SERVICE BULLETIN: JSB 031-1

Date: 14th April 2011

Subject: Jabiru Engine Through-Bolts

Figure 2 – 12-Point Nuts

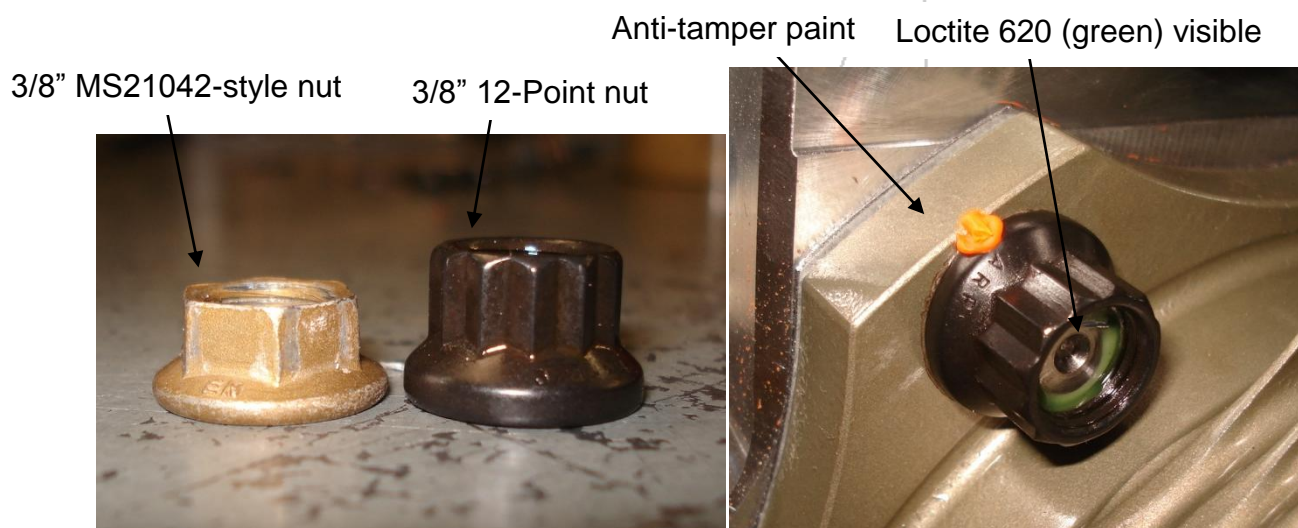
- Testing has shown that 12-point nuts (Figure 2) can carry a slightly higher load than the original MS21042 type nuts. As they are longer they also spread the tension load over a higher number of threads on the bolt. This reduces the load concentrated on any given thread and improves the ultimate strength and fatigue life of the assembly.

- Any engine which is being overhauled or having major maintenance carried out should be upgraded as follows:
 - a) The existing MS21042 style nuts must be replaced with 3/8" 12-point nuts.

- If the 12-point nuts are used on the original through-bolts then they will overhang the studs as shown in Figure 2 (right) due to their extra length. Normal aircraft practice is to ensure that a minimum of around 1.5 threads project through the nut, however in this case that is not necessary. Figure 3 shows an illustration of 3 through-bolts fitted to an engine. It can be seen that the thread projects the required amount from the old MS21042-style nut but is recessed inside the 12-point nut. However, due to its extra length the 12-point nut is actually engaging with at least 1.5 – 2 threads more and produces a stronger connection. Also, during assembly with “short” through-bolts it is necessary to put one nut in position and then lock it there by screwing a 3/8” UNF bolt into the recess so that the nut on the other end of the stud can be tightened (with the MS21042 style nuts the same thing was achieved by screwing a second nut onto the protruding thread as a lock nut).

- The base of the 12-point nuts must still be lightly chamfered when used on older cylinder barrels to clear the radius at the base of the cylinder. Newer cylinders, like that shown in Figure 2 (right) are a different design and may not need chamfered nuts – but overhaulers must confirm this before final assembly.

- Because these nuts are not self-locking Loctite 620 must be used. Loctite 620 is used because of its strength at elevated temperatures and because it does not act as a strong lubricant when tightening the nut. Using a locking compound on these nuts forces a new installation technique:

- Assemble the engine and tighten all through-bolts and studs to 20lb.ft **without** locking compound.
 - Starting from the middle cylinders, remove both nuts from one through-bolt, clean, prime, apply Loctite 620 (approximately the size of 2 match heads applied to threads only – do not apply to flange of nut) and tighten. This must be done quickly, before the Loctite starts to cure. Torque settings are given in the engine overhaul manual.

- Mark the completed nuts with anti-tamper paint as shown in Figure 2 (right).
 - Repeat this process on all the remaining through-bolts and studs, working outwards from the middle cylinders as normal.
